# Yoakum Dunes WMA- ADA Evaluation

**Accessibility Evaluation**

**Inspection Date: 06/24/2022**

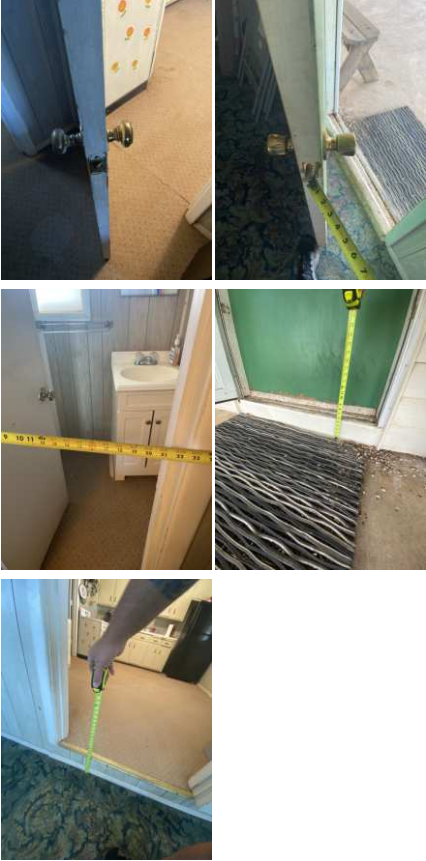
Finding Number	Area Description	Finding	As Built	Recommendation	Citation	Photos	Figure
1	Exterior of Property (Public): HQ Parking Lot (1 Space) 1 Labeled - Accessible Stall (Labeled)	The accessible parking stall signage is incorrect and/or missing from each accessible parking space. Parking space identification signs shall include the International Symbol of Accessibility. Signs identifying van parking spaces shall contain the designation "van accessible." Signs shall be 60 inches minimum above the finish floor or ground surface measured to the bottom of the sign.	Missing van designation		<a href="https://www.access-board.gov/ada/#ada-502_6">https://www.access-board.gov/ada/#ada-502_6</a>	2012 TAS Section: 502.6  2015 ABAAS Section: 502.6	 
2	Exterior of Property (Public): HQ Parking Lot (1 Space) 1 Labeled - Accessible Stall (Labeled)	The parking sign is mounted too low. Parking space identification signs shall include the International Symbol of Accessibility. Signs identifying van parking spaces shall contain the designation "van accessible." Signs shall be 60 inches minimum above the finish floor or ground surface measured to the bottom of the sign.	Sign height at 54"		<a href="https://www.access-board.gov/ada/#ada-502_6">https://www.access-board.gov/ada/#ada-502_6</a>	2012 TAS Section: 502.6  2010 ADAS Section: 502.6  2015 ABAAS Section: 502.6

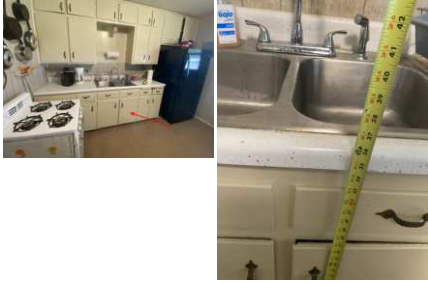
Finding Number	Area Description	Finding	As Built	Recommendation	Citation	Photos	Figure
		panels that permit viewing through the panels shall have the bottom of at least one glazed panel located 43 inches (1090 mm) maximum above the finish floor. EXCEPTION: Vision lights with the lowest part more than 66 inches (1675 mm) from the finish floor or ground shall not be required to comply with 404.2.11. Egress doors shall provide a continuous and unobstructed way of egress travel from any point in a building or facility that provides an accessible route to an area of refuge, a horizontal exit, or a public way.					
9	Structures on Property (Public) : Bunk Areas (Interior) - Entrance/Exit Doors	The floor mat at the door is not secured in place. If carpet or carpet tile is used on a ground or floor surface, then it shall be securely attached; have a firm cushion, pad or backing or no cushion or pad; and have a level loop, textured loop, level-cut pile or level-cut/uncut pile texture. The maximum pile height shall be 1/2 inch. Exposed edges of carpet shall be fastened to floor surfaces and have trim along the entire length of the exposed edge. Recessed doormats shall be adequately anchored to prevent interference with wheelchair traffic.	Door mat is not of compliant size or durability and does not meet compliance.	<a href="https://www.access-board.gov/ada/#ada-302_2">https://www.access-board.gov/ada/#ada-302_2</a>	2012 TAS Section: 302.2 2010 ADAS Section: 302.2 2015 ABAAS Section: 302.2

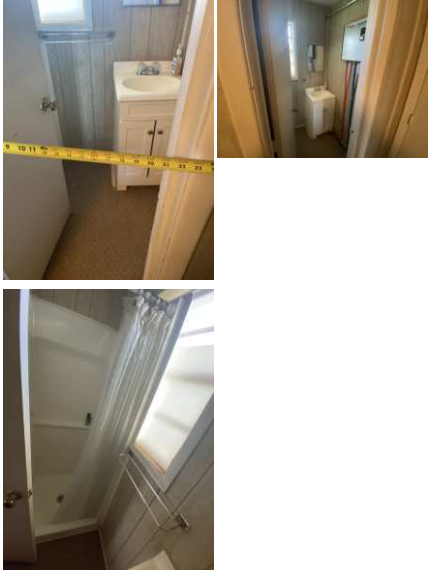
Finding Number	Area Description	Finding	As Built	Recommendation	Citation	Photos	Figure
11	Structures on Property (Public) : Bunk Areas (Interior) - Entrance/Exit Doors	The threshold is greater than 1/2 inch high. The threshold at a doorway shall be no higher than 1/2 inch. Changes in level between 1/4 inch and 1/2 inch must be beveled at 1:2 or less. 1/4 inch is the maximum vertical rise.	Threshold exceeds 1/2"		<a href="https://www.access-board.gov/ada/#ada-404_2_5">https://www.access-board.gov/ada/#ada-404_2_5</a>	2012 TAS Section: 404.2.5  2010 ADAS Section: 404.2.5  2015 ABAAS Section: 404.2.5	
12	Structures on Property (Public) : Bunk Areas (Interior) - Entrance/Exit Doors	The operating hardware requires tight grasping, pinching or twisting of the wrist to operate. Hand-activated hardware, handles, pulls, latches, locks, and other operating devices on accessible elements shall have a shape that is easy to grasp with one hand and does not require tight grasping, pinching or twisting of the wrist to operate.	Door knobs throughout building are not compliant.		<a href="https://www.access-board.gov/ada/#ada-309_4">https://www.access-board.gov/ada/#ada-309_4</a>	2012 TAS Section: 309.4  2010 ADAS Section: 309.4  2015 ABAAS Section: 309.4

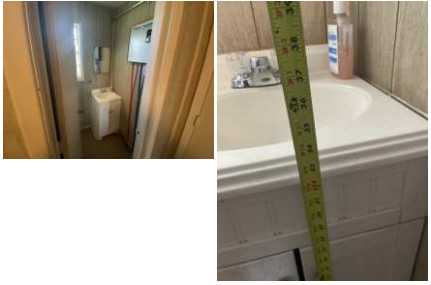
13	Structures on Property (Public) : Bunk Areas (Interior) - Kitchenette	There is a change in level greater than 1/4 inch. 1/4 inch is the maximum vertical rise. Changes in level between 1/4 inch and 1/2 inch must be beveled at 1:2 or less. Changes in level greater than 1/2 inch must be by way of a ramp.	Living area into kitchen, thresholds exceeds 1/2" tolerance.		<a href="https://www.access-board.gov/ada/#ada-303_3">https://www.access-board.gov/ada/#ada-303_3</a> <a href="https://www.access-board.gov/ada/#ada-303_2">https://www.access-board.gov/ada/#ada-303_2</a>	2012 TAS Section: 303.3  2010 ADAS Section: 303.3  2015 ABAAS Section: 303.3

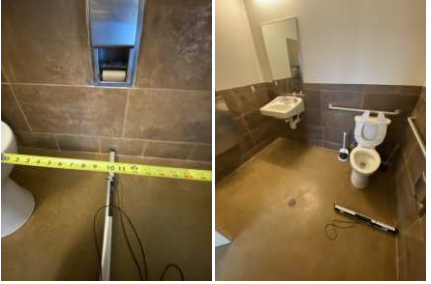
15	Structures on Property (Public) : Bunk Areas (Interior) - Kitchenette	The top of the sink is above the allowable height requirement. Sinks shall be installed with the front of the higher of the rim or counter surface 34 inches maximum above the finish floor or ground.	Sink height at 36" Sink required to have frontal approach due to stove top in kitchenette	N/A - Refer to Finding	2012 TAS Section: 606.3  2010 ADAS Section: 606.3  2015 ABAAS Section: 606.3		
16	Structures on Property (Public) : Bunk Areas (Interior) - Kitchenette	Compliant knee and/or toe clearance is not provided. When seating for persons in wheelchairs is provided at fixed tables or counters, knee spaces at least 27 inches high, 30 inches wide, 11 inches deep, and toe clearance extending an additional 6 inches at 9 inches high shall be provided. The toe clearance shall extend 17" minimum under the element.	Kitchen table is not accessible and does not provide knee or toe space.	<a href="https://www.access-board.gov/ada/#ada-306_2_1">https://www.access-board.gov/ada/#ada-306_2_1</a>	2012 TAS Section: 306.2.1  2010 ADAS Section: 306.2.1  2015 ABAAS Section: 306.2.1, 306.3.1
